TABLE 4.12-1 - SHEET 1

SAFETY EVALUATION

Re: Turkey Point Units 3 & 4
Docket Nos. 50-250 & 50-251
Proposed License Amendment
Environmental Surveillance Program

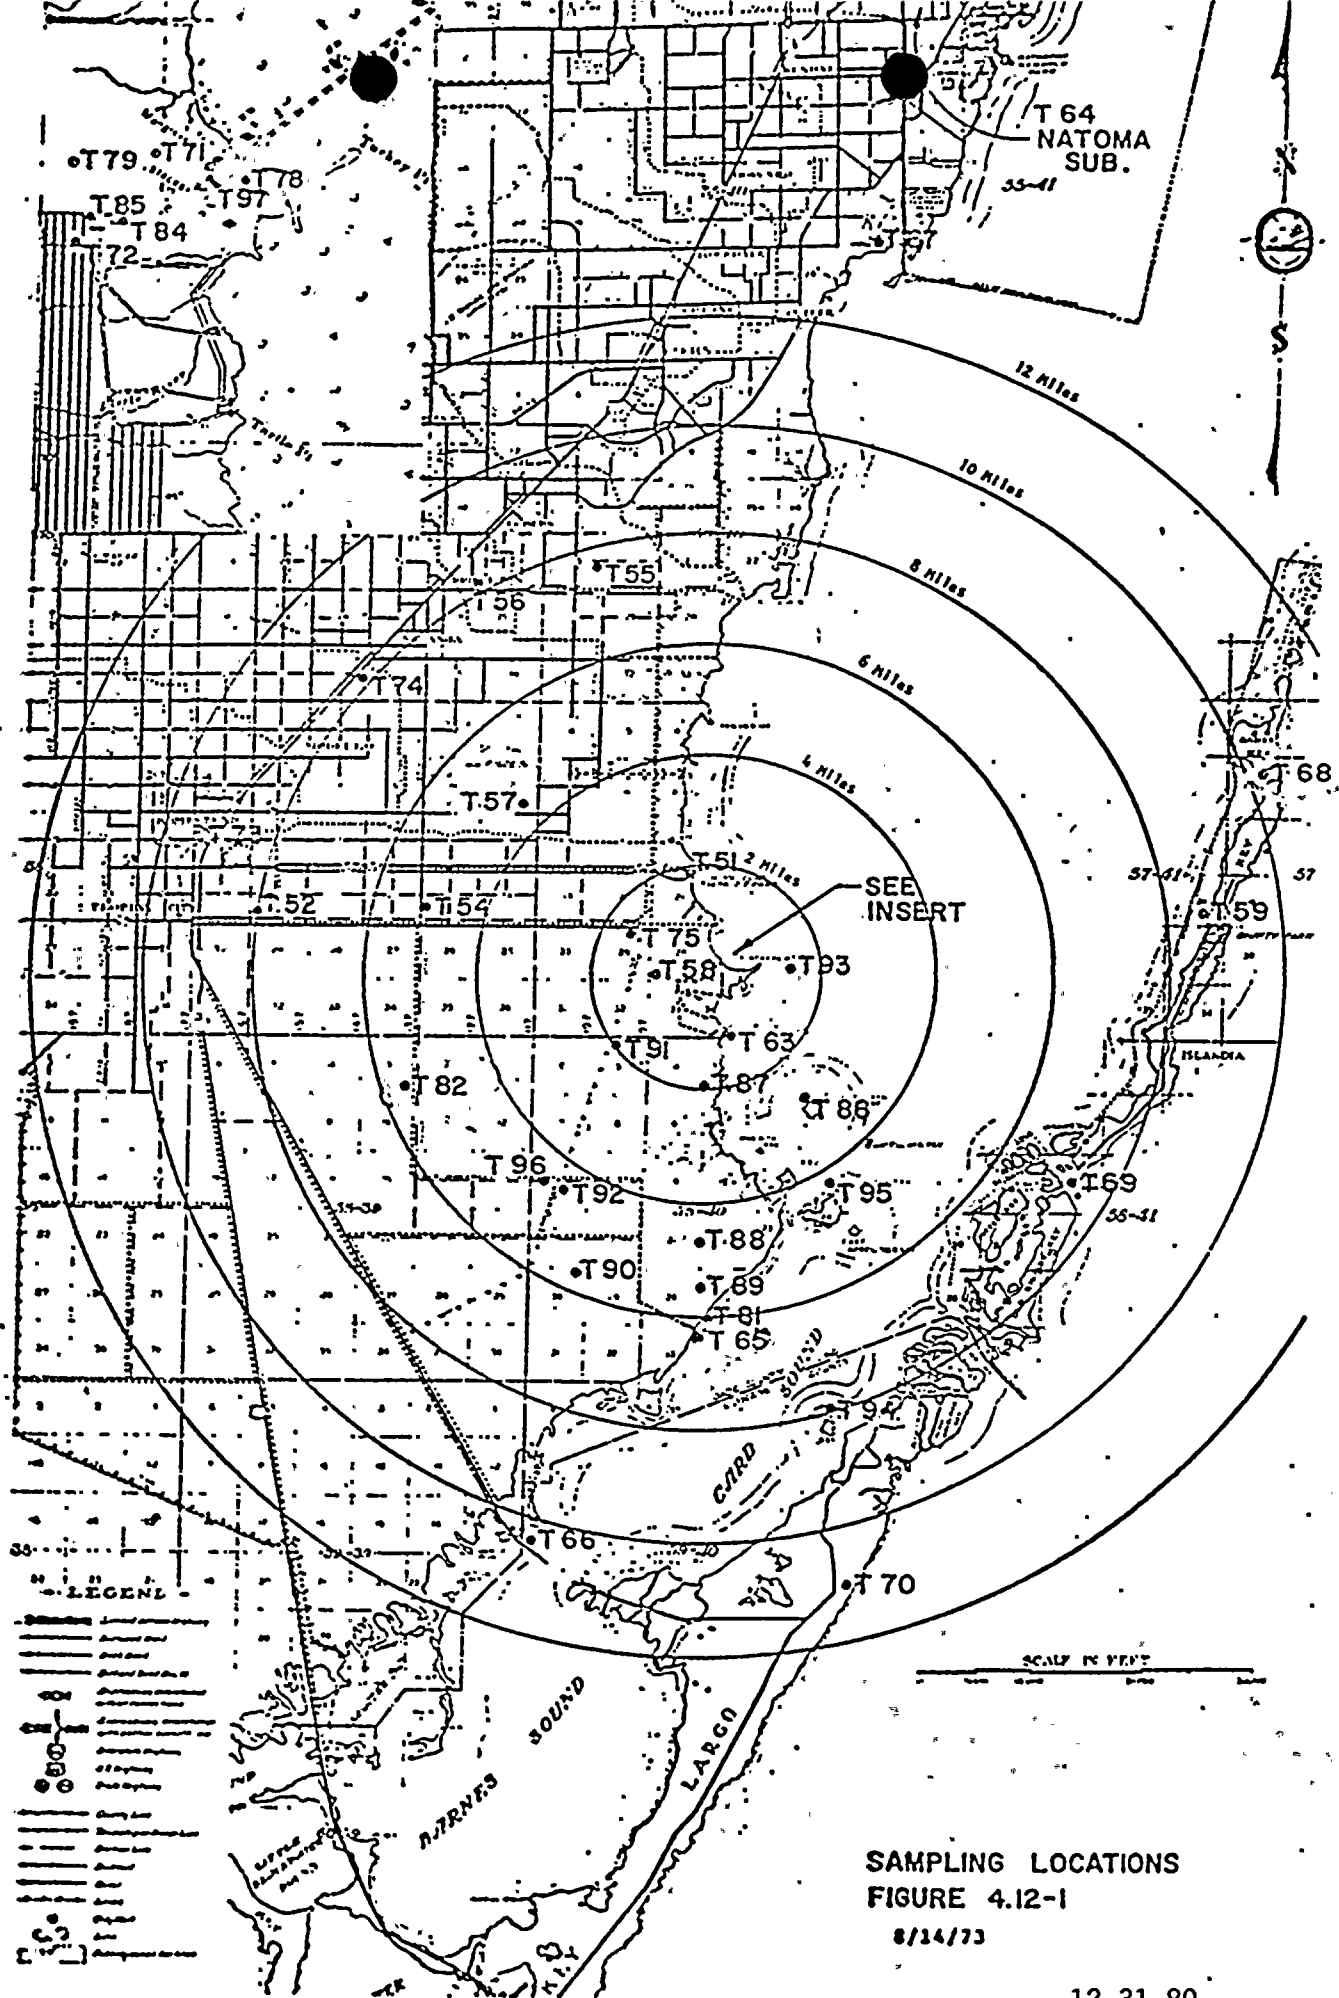
Table 4.12-1, Sheet 1 presently lists T79 as the on-site precipitation sampling location (see Technical Specification Figure 4.12-1 attached for information). This location is near the site boundary station along the entrance road into the plant. In February and March of this year, the precipitation sample at location T79 was unusable due to motor oil contamination. The sampling drum is easily accessible from the entrance road, and used motor oil was apparently introduced into the drum by a person or persons unknown.

Since the site boundary station is unmanned, and since the entrance road adjacent to location T79 is heavily travelled, it was decided to relocate the precipitation sampling drum to location T72. The new location is on-site, and, as shown on Figure 4.12-1, it is relatively near the old location (approximately 1 mile distant). Access to location T72 is also controlled through a manned security gate.

This evaluation supports a basically administrative change in Technical Specification Table 4.12-1, which lists various environmental surveillance requirements. Precipitation sample location T79 is changed to location T72.

The change in sample location is necessary to ensure the capability of obtaining reliable monthly precipitation samples from an on-site location. With respect to rainfall, there is no significant difference between locations T79 and T72, and relocation to T72 does not have any safety implications.
